DOCKETED			
Docket Number:	12-AFC-02		
Project Title:	Huntington Beach Energy Project		
TN #:	202631		
Document Title:	Opening Testimony of Monica Rudman on the Huntington Beach Energy Project		
Description:	N/A		
Filer:	Monica Rudman		
Organization:	Monica Rudman		
Submitter Role:	Public		
Submission Date:	6/30/2014 10:34:36 AM		
Docketed Date:	6/30/2014

In the Matter of:		
Huntington Beach Energy Project	DOCKET NO. 12-AFC-02

OPENING TESTIMONY OF MONICA RUDMAN ON THE HUNTINGTON BEACH ENERGY PROJECT

Figure 1. Picture of Huntington Beach Generating Station taken from Newport Pier

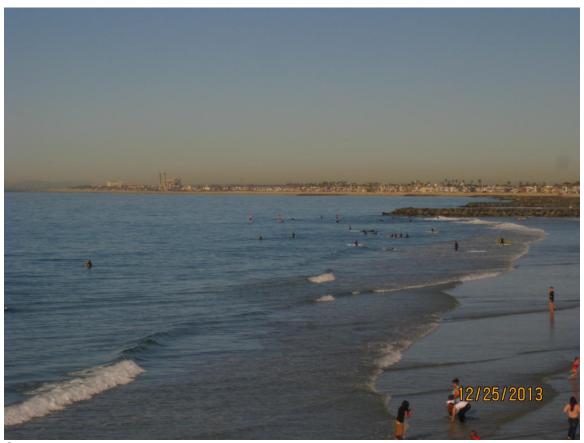
The HBEP would have a significant impact on a scenic vista. While the proposed project will have a lower height than the existing HBGS and the applicant is proposing to screen it with a 100-foot faux—surfboard structure, it will still be located primarily among one and two story buildings and be visible from a great distance. The new project will still dominate the views on the coast. Please note that a key observation point has been omitted from staff and the applicant's consideration: the Newport coast. Please refer to Figure 1. to see a picture of the view from the Newport Pier on a winter morning. Even with a lower height, it is clear that the project will still dominate the views north of the Newport Pier.
